Item #1 Soft Housings There have been a number of reported incidents of unusually high pull forces needed to release the main canopy in a malfunction situation. The situation has been encountered on systems using soft housings and mini risers. It reportedly has only happened with malfunctioning small high performance canopies which have twisted the risers tightly before release action could be initiated.

Item #3 EOS Reserve Pilot Chute Upgrade Para-Flite has upgraded their EOS reserve pilot chute to incorporate the following improvements:

Item #4 Strong Enterprises Bulletin Strong Enterprises issued Product Service Bulletin #22 on 20 February, 1997 which affects their Dual Hawk Tandem. This two part bulletin requires mandatory compliance prior to 20 May, 1997.

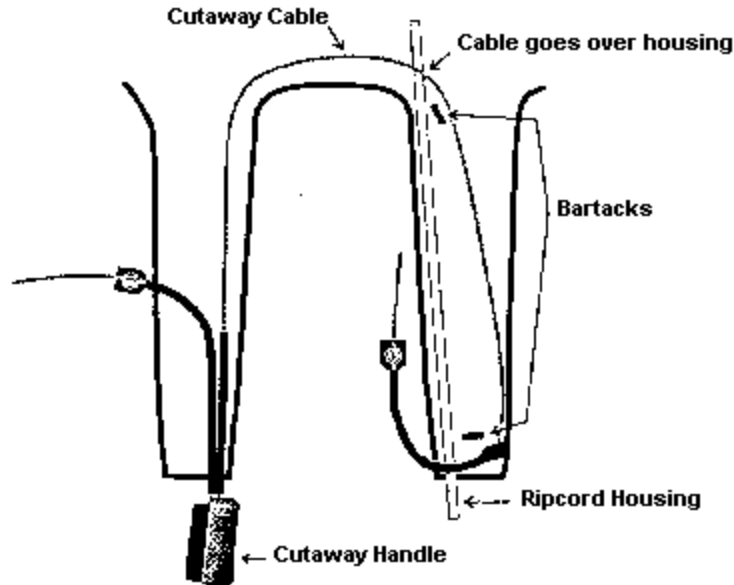
Sun Path, makers of the Javelin, have used soft housings for a number of years and continue to do so. They tend to think some of the hard pull situations could have been averted if the longer release cable had been correctly routed. A diagram follows which shows correct routing.

Soft housings can be replaced with metal housings by a qualified Rigger "A" as long as they only require hand tacking. Any required machine sewing would need to be performed by a Rigger "B". Details of housing change-over can be obtained from Sun Path Products Inc., 5037 Gall Blvd., Zephyrhills, Florida 33541 Phone: (813) 782-9242 Fax: (813) 788-3057
